October 23, 2019

**RE: RESPONSE TO TCEQ ADDITIONAL COMMENTS LETTER DATED SEPTEMBER 6, 2019  
UNION PACIFIC RAILROAD COMPANY – HOUSTON WOOD PRESERVING WORKS  
HOUSTON, HARRIS COUNTY, TEXAS  
HAZARDOUS WASTE PERMIT/COMPLIANCE PLAN NO: 50343, ISWR NO 31547  
EPA IDENTIFICATION NO TXD000820266; RN100674613/CN600131098**

PROJECT NO. 19119232	REV. 0	ATTACHMENT 2A-1a
-------------------------	-----------	---------------------

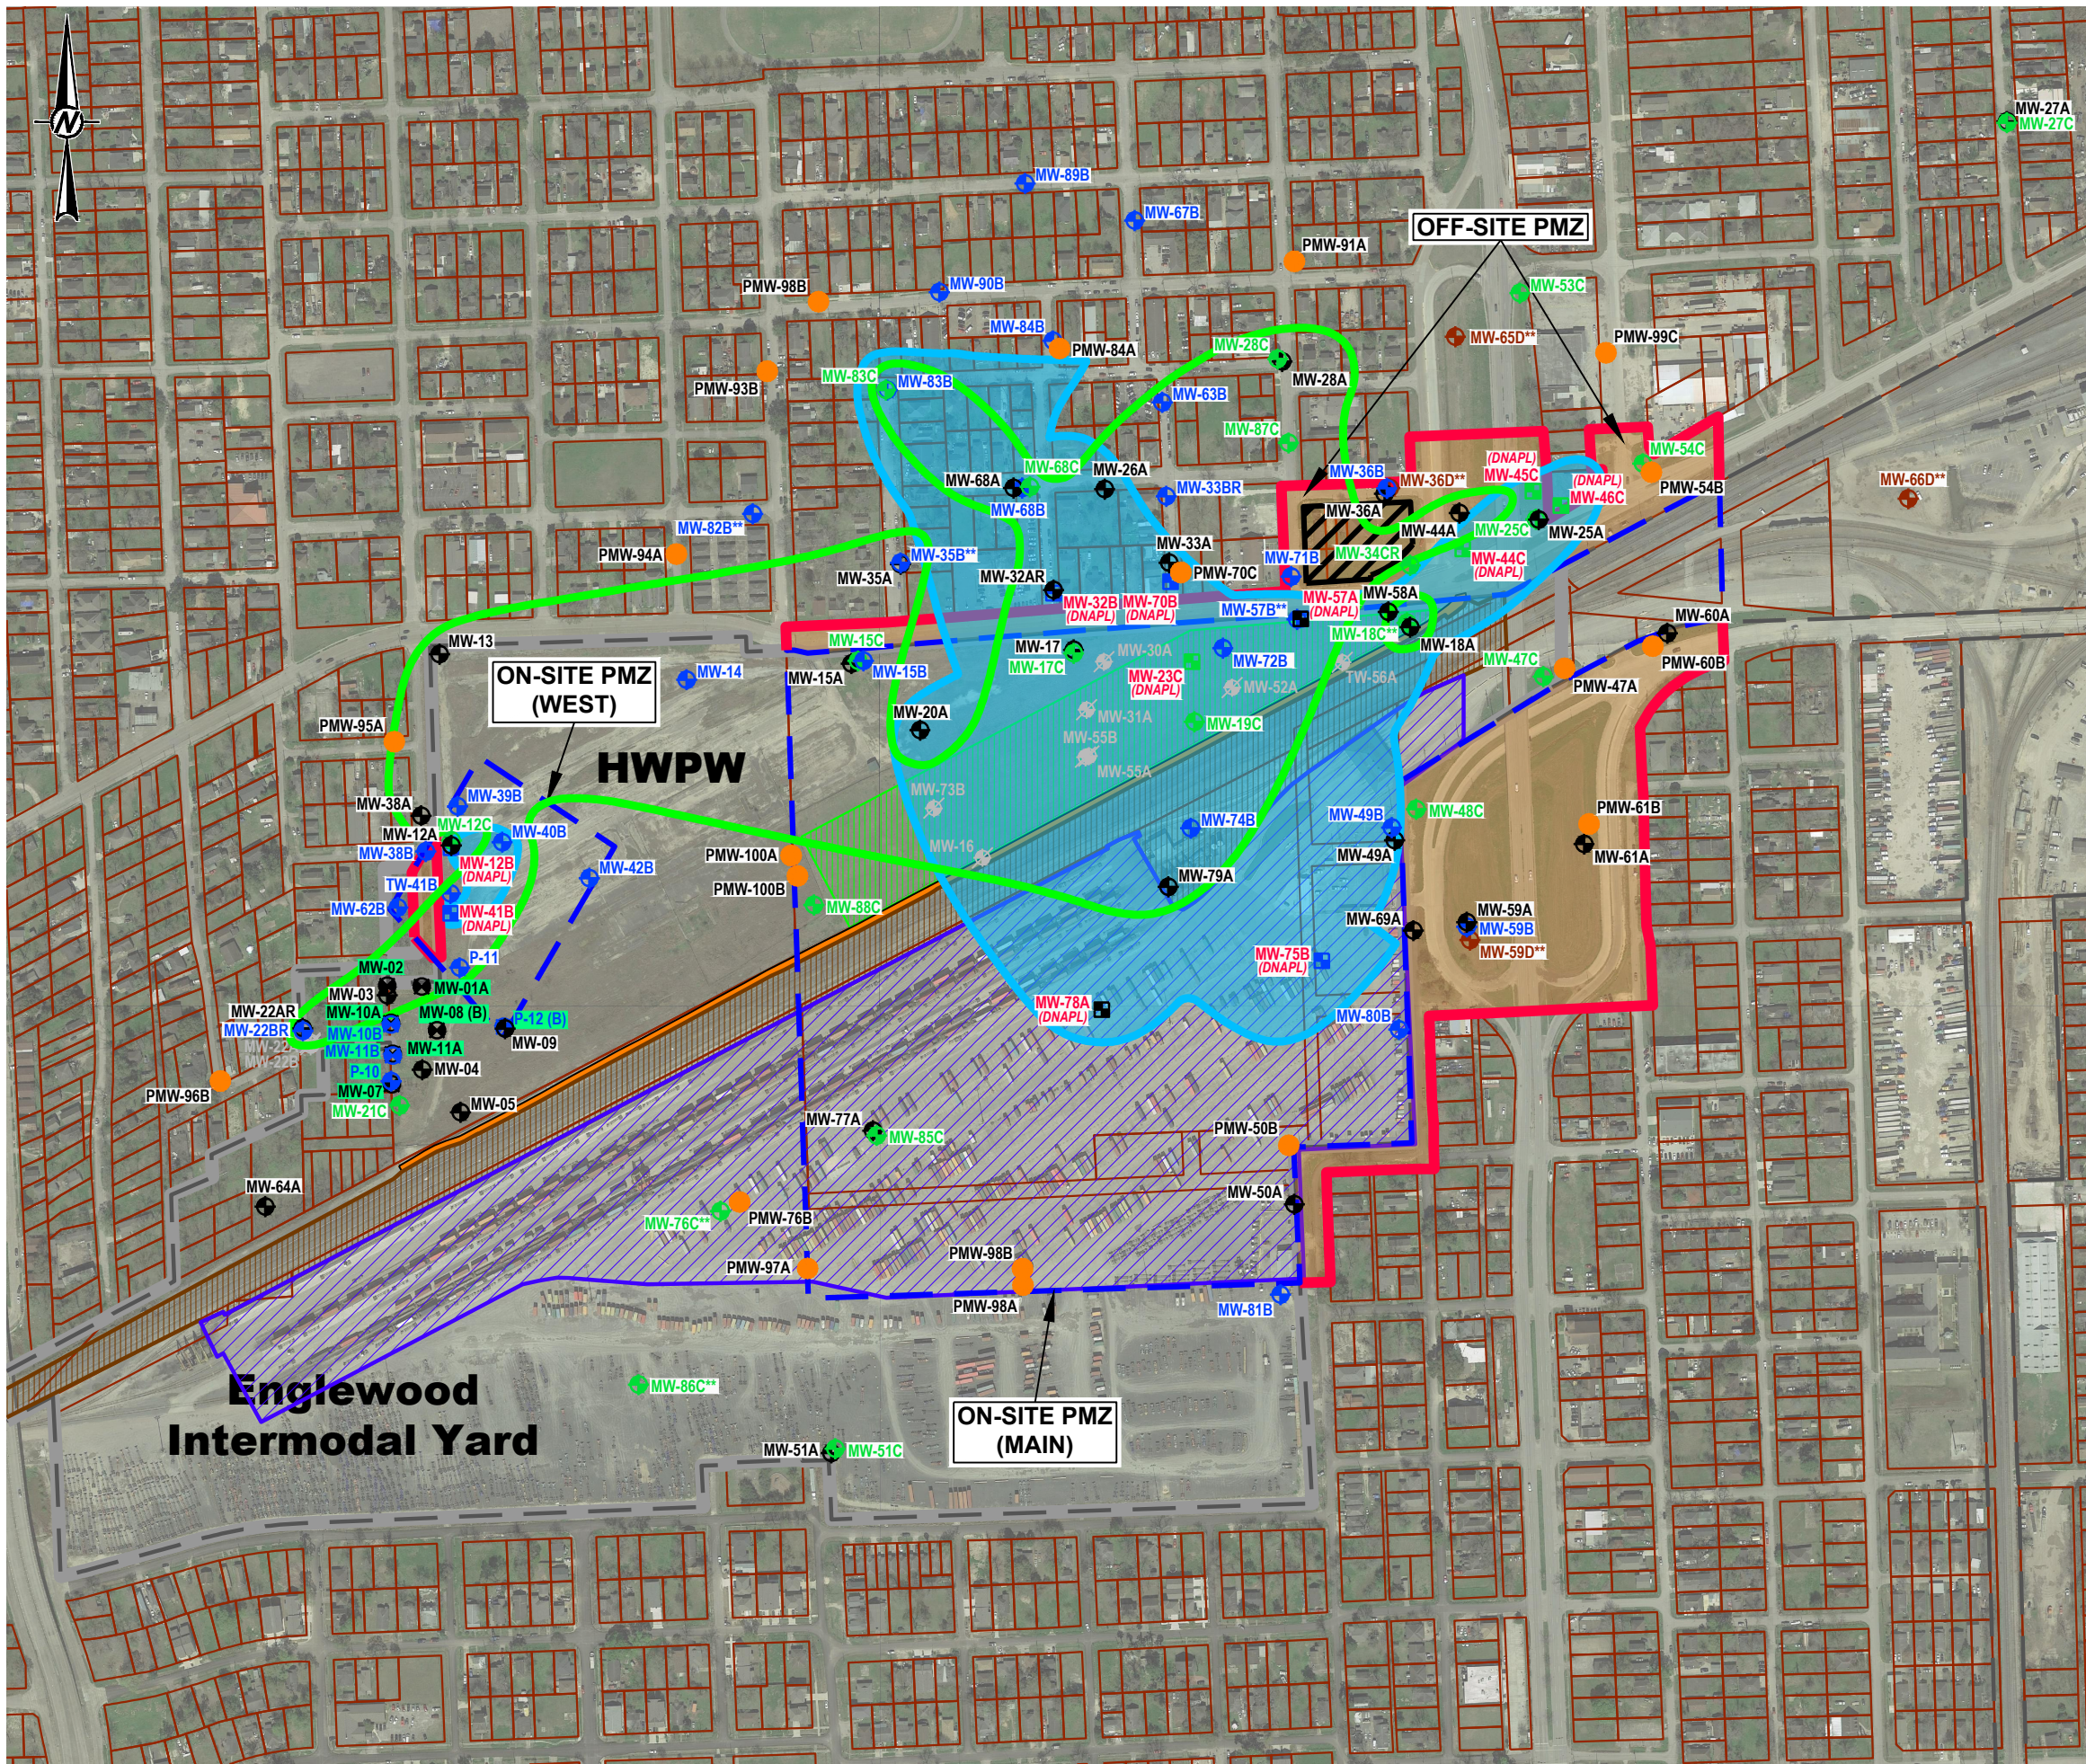
1. *As part of the proposed TPH Non-aqueous phase liquid (NAPL) assessment, UPRR proposes to collect continuous samples down to the top of the uppermost groundwater bearing unit (A-TZ) at 23 soil boring locations, shown in Attachment 2A-1a, to be logged and screened with an organic vapor meter (OVM). UPRR also proposes to submit up to two soil samples at each boring for lab analysis using TPH Method TX1005. Depending on the field screening results (e.g. OVM reading, observations of visual hydrocarbon screening, etc.) it may be necessary to submit more than two soil samples per boring location for TPH Method TX1005 analysis to adequately delineate affected soils vertically - pursuant to 30 TAC §350.51(d) which requires the vertical extent of affected soils be delineated to the higher of the method quantitation limit (MQL) or background. Secondly, UPRR needs to collect additional samples near the locations of the former two lagoons and three former 55,000 barrel above ground storage tanks (AST) to adequately characterize the potential source areas. Please see these approximate locations on the attached Figure 2A-1a.*

2. *In Attachment 2A-1a, UPRR includes proposed locations to conduct cone penetrometer (CPT)/Tar-specific Green Optical Screening Tool (TarGOST) as part of the NAPL Assessment that includes: 20 locations on UPRR property in the Englewood Intermodal Yard; four locations on the western UPRR property boundary; 10 locations at the north UPRR property boundary; four locations along the east UPRR property boundary; and eight locations offsite north of the UPRR property boundary. Additional locations need to be included in the CPT/TarGOST as shown in the attached Figure 2A-1a to delineate extent of NAPL that may have migrated beyond the facility property boundary. Once the CPT/TarGOST assessment begins, the TCEQ understands that some of the locations may need to be adjusted due to field conditions, infrastructure, and additional step out assessment as needed.*

Although initially the TCEQ requested that UPRR install up to seven additional soil borings to assess the former source areas located within the Englewood Intermodal Yard during the TCEQ meeting, the TCEQ agreed that only one additional TPH assessment soil boring location within the area of the former lagoons and former above ground storage (AST) is necessary. Further, as agreed, UPRR proposes to consider the other TCEQ suggested soil boring locations as contingency locations shown on the revised Attachment 2A-1a that may be drilled and sampled depending on the CPT-TarGOST results located near the suggested soil boring locations. If significant TarGOST responses (i.e., in intensity and/or different TarGOST signatures) are observed at the location, UPRR will drill and sample the soils in the vadose zone and TPH soil samples will be collected from the contingency locations. To aid the TCEQ in review of the proposed locations, estimated location of the former lagoons and ASTs are shown on revised Attachment 2A-1a.

As discussed during the TCEQ meeting, UPRR will add up to five CPT/TarGOST locations on the northeast side of the Site near the crossing of Liberty Road and the Lockwood Bridge overpass (see Attachment 2A-1a). Locations in this area may need to be revised based on underground and overhead utilities. UPRR proposes to consider the additional CPT/TarGOST locations suggested by the TCEQ in the September 6, 2019 letter off site east and west of the Site as contingency locations. This approach will allow the field data to dictate the need for additional CPT/TarGOST locations. UPRR will conduct the proposed CPT/TarGOST locations within the Site along the east and west perimeter, and depending on the TarGOST results from those locations, UPRR will then conduct CPT/TarGOST borings off-site at the contingency locations as needed (see revised Attachment 2A-1a for the proposed contingency locations).

PROJECT NO.	REV.	FIGURE
19119232	0	2A-2

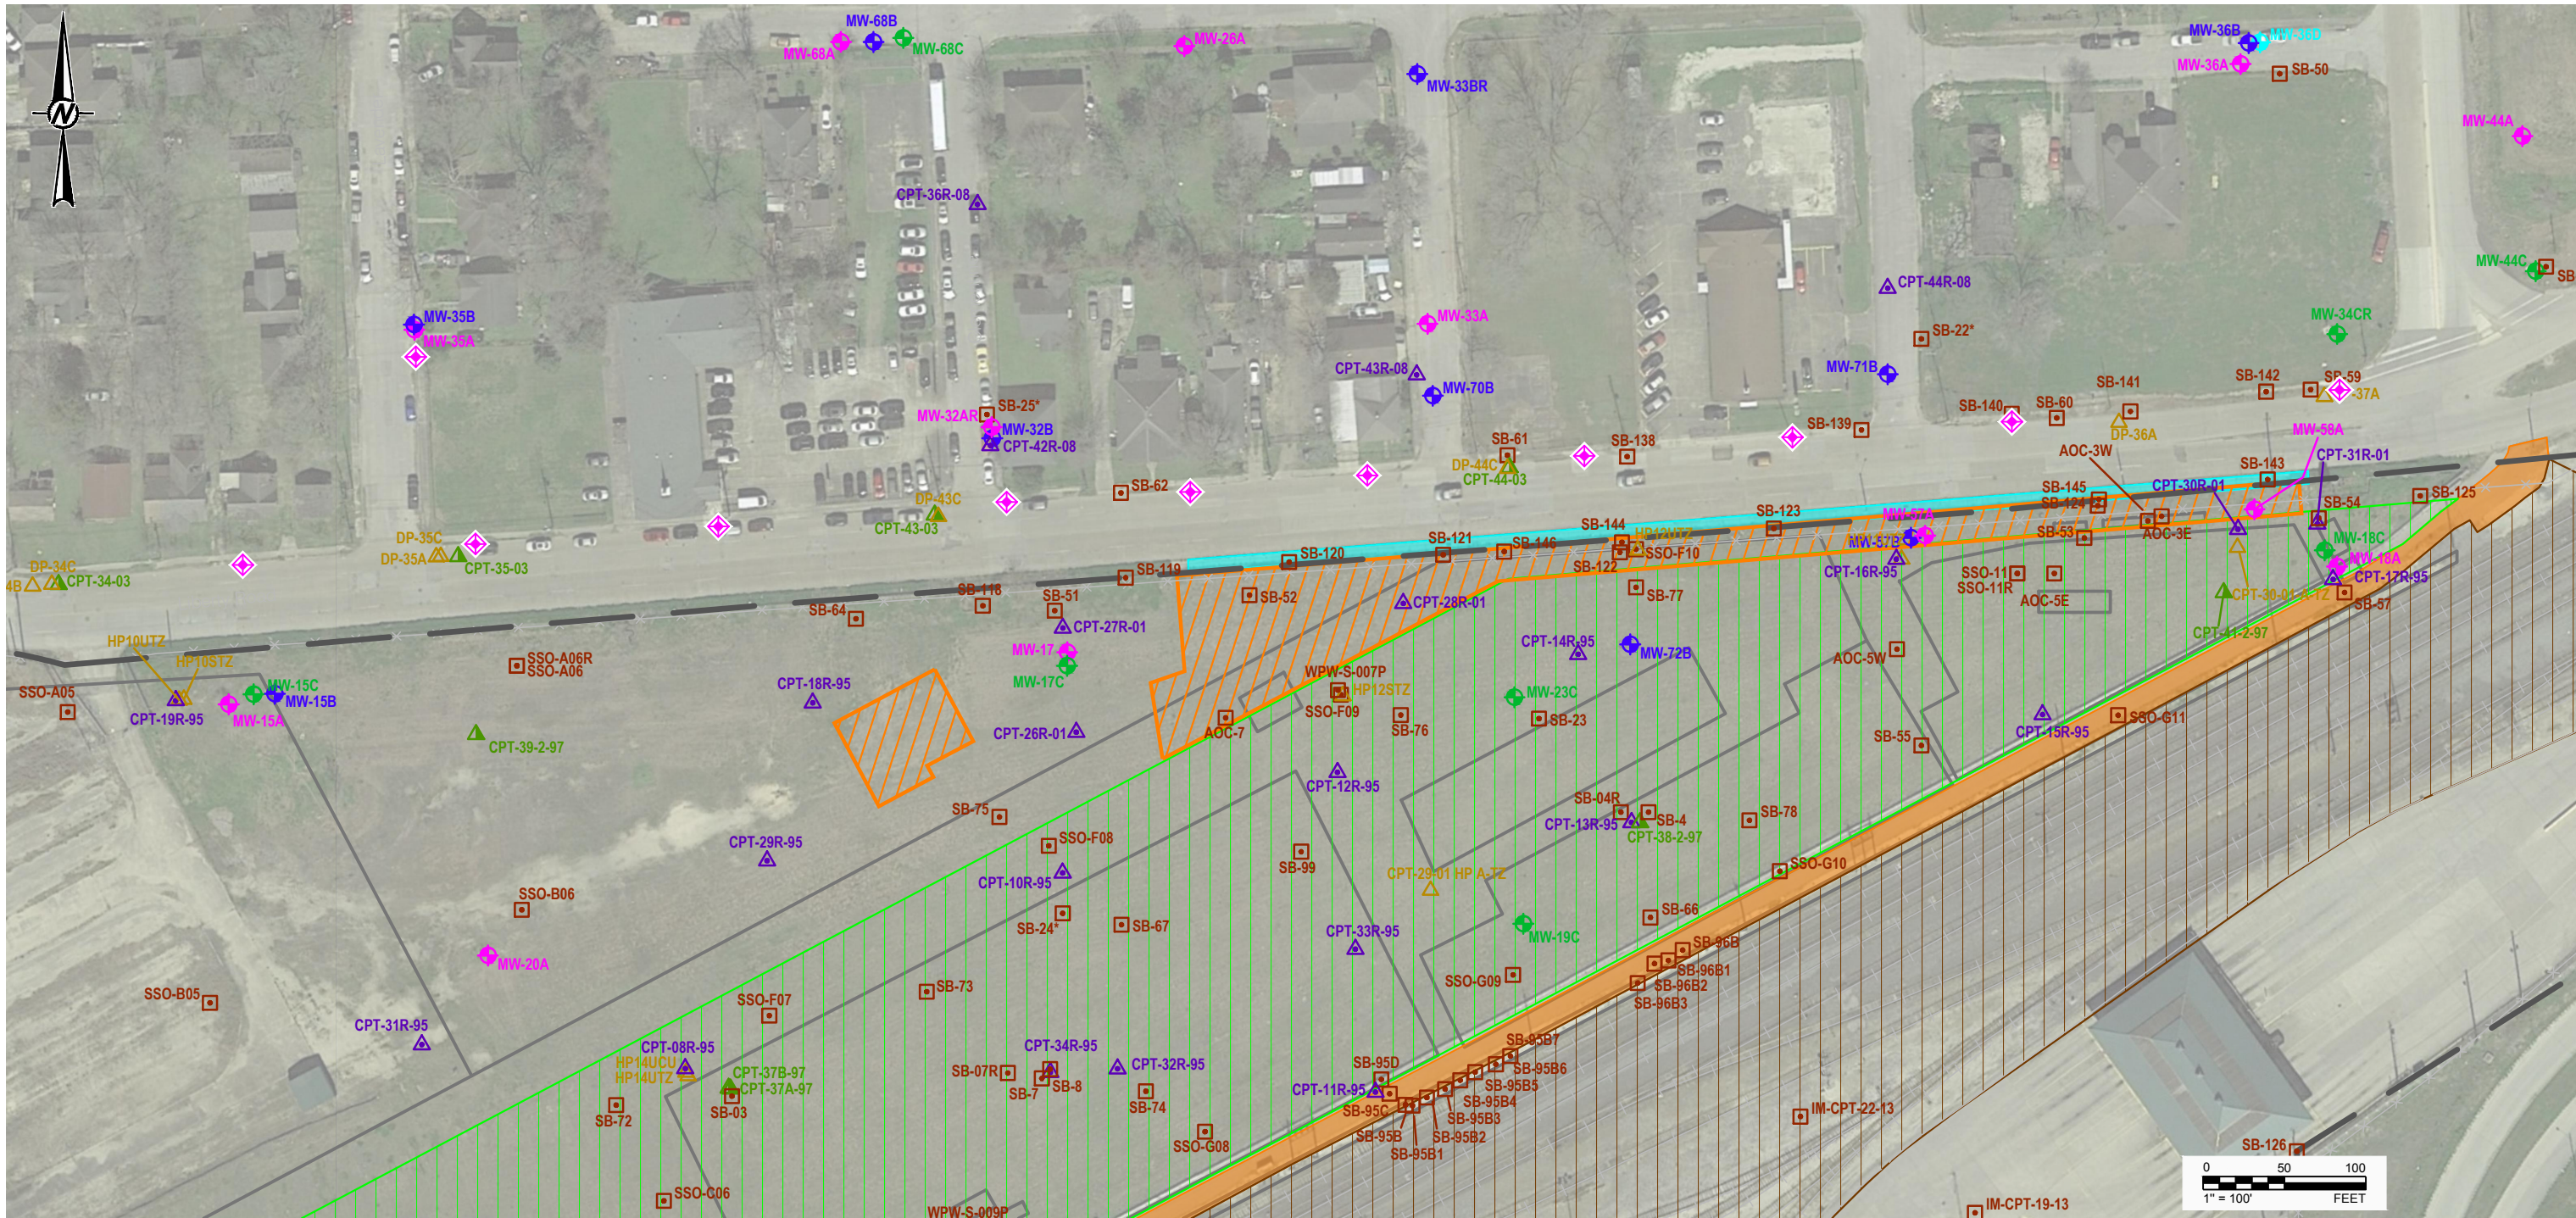
4. *For Attachment 2A-2, showing proposed locations monitor well installation, UPRR needs to include additional monitoring wells to provide adequate delineation of affected groundwater in the AT-Z and BC/BTZ zones. Please see attached Figure 2A-2 for these approximate locations.*

As agreed during the TCEQ meeting to adequately delineate affected groundwater, the revised number of proposed monitoring well locations are shown on the revised Attachment 2A-2 enclosed with this letter. This will result in the addition of the following wells (including the monitoring wells proposed in the July 10, 2019 submittal) completed in their respective GWBUs:

- A-TZ: Eight wells
- B-CZ/B-TZ: Ten wells
- C-TZ: Two wells

PROJECT NO. 19119232  
REV. 0  
FIGURE 1

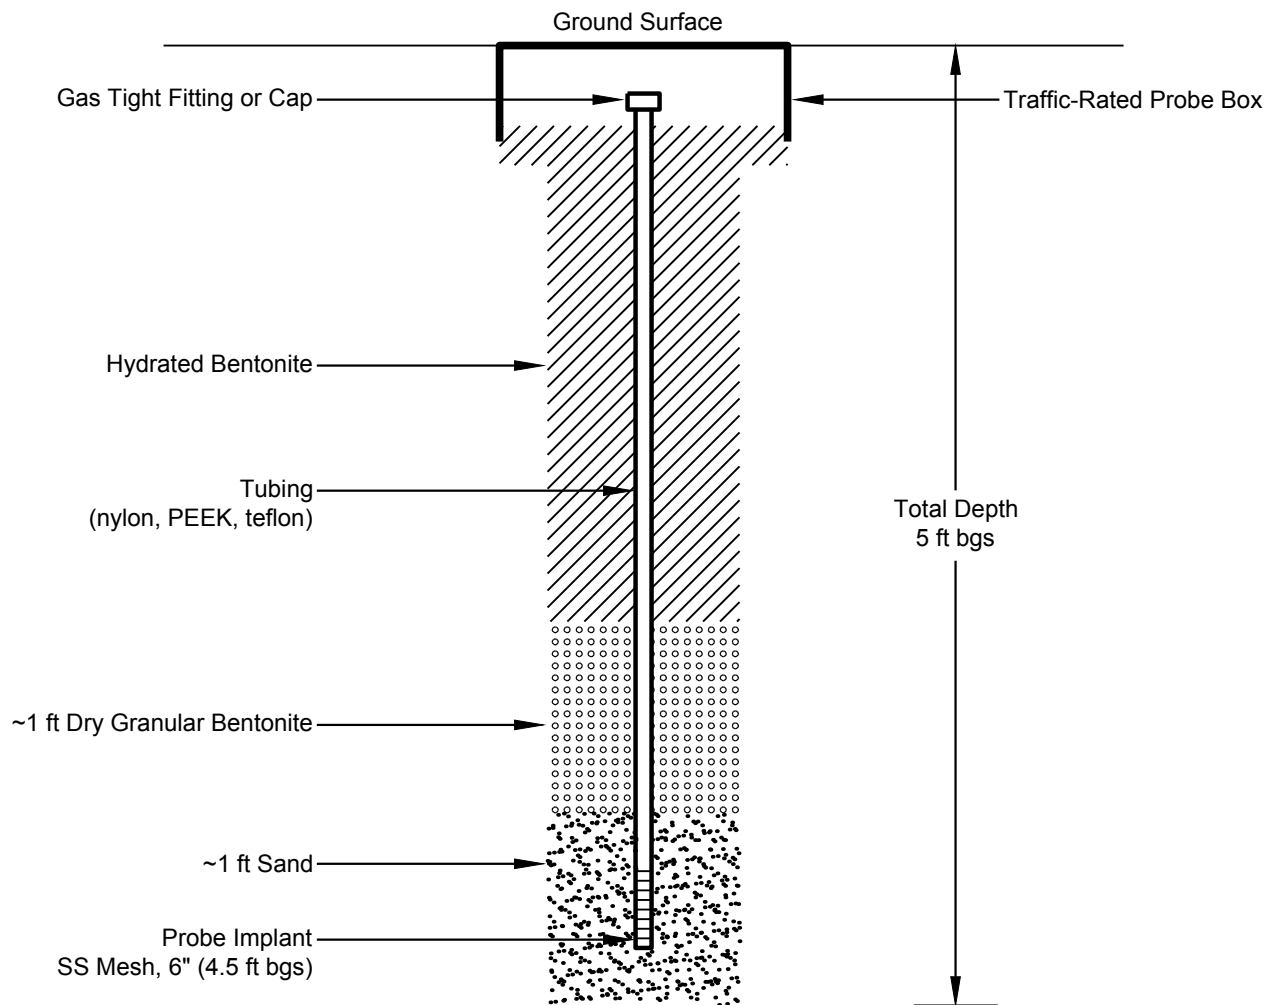
- a. *Off-site wells are needed to fully delineate all COCs where elevated naphthalene concentrations were observed in the MW-35A area.*
  - b. *Several more off-site wells are needed between MW-15A and MW-58A at the property boundary, and off-site on the northside of Liberty Road to fully delineate all COCs. Starting at well MW-15A, new wells should be installed approximately 100 feet apart extending to well MW58A. This will include a line of new wells along the on-site property line and a corresponding line of new wells located off-site on the northside of Liberty Road. In addition to the delineation, the COC results will provide information to evaluate if VISL (EPA, 2018) screening levels for the target groundwater concentration and the calculated indoor air concentrations are exceeded. Additionally, the results may allow for establishment of a lateral*

*c. Vadose zone soil samples should be collected and analyzed for all COCs at 2-foot intervals for all newly installed wells to determine whether the vadose zone soil is impacted by COCs. The primary purpose of analyzing the vadose zone soils is to determine if there is adequate vertical separation distance between the impacted groundwater and the ground surface, as outlined in EPA's 2015 Technical Guide for Addressing Petroleum Vapor Intrusion at Leaking Underground Storage Tank Sites.*

*d. Soil samples should also be collected from the vadose zone in the immediate vicinity of MW-35A.*

As an alternative evaluation for the VI pathway, UPRR proposes to conduct a soil gas assessment on the north side of Liberty Road. The proposed soil gas locations will be spaced between 100 and 200 feet from each other within the City of Houston right-of-way (ROW) sidewalk, with the proposed locations in general alignment with buildings off-site. In addition, to address the potential for the VI pathway near MW-35A per comment 5a, a soil gas probe will be installed within the City of Houston ROW east of MW-35A. UPRR proposes to install a total of 11 soil gas probes at the offsite locations as shown on Figure 1.

UPRR will advance soil borings to approximately 5 feet below ground surface and will install the probes through the concrete sidewalk using a hand auger to mitigate the risks of potentially damaging unmarked/unknown utilities at approximately 4.5 to 5 ft bgs. During the hand auger activities, two soil samples will be collected (0.5-1 feet below ground surface and from 4-5 feet bgs) and analyzed for Site-specific COCs and soil moisture to evaluate the vertical separation distance as outlined in EPA's 2015 *Technical Guide for Addressing Petroleum Vapor Intrusion at Leaking Underground Storage Tank Sites*. Then we will install traffic-rated probe vaults (i.e., boxes) to protect soil gas probes and allow for future sampling. Proposed construction details of the soil gas probes are provided in Figure 2. Finally, UPRR will collect and submit the soil gas samples to the laboratory to selectively analyze soil gas samples for benzene, ethylbenzene, xylenes, and naphthalene by the appropriate analytical methods.

As discussed in the response to 5b, UPRR proposes to collect soil samples from each of the soil gas borings (including just east of MW-35A in the City of Houston ROW) for the 0.5-1-foot interval and 4-5-foot interval. Soil samples will be analyzed for Site-specific COCs and soil moisture to evaluate the vertical separation distance as
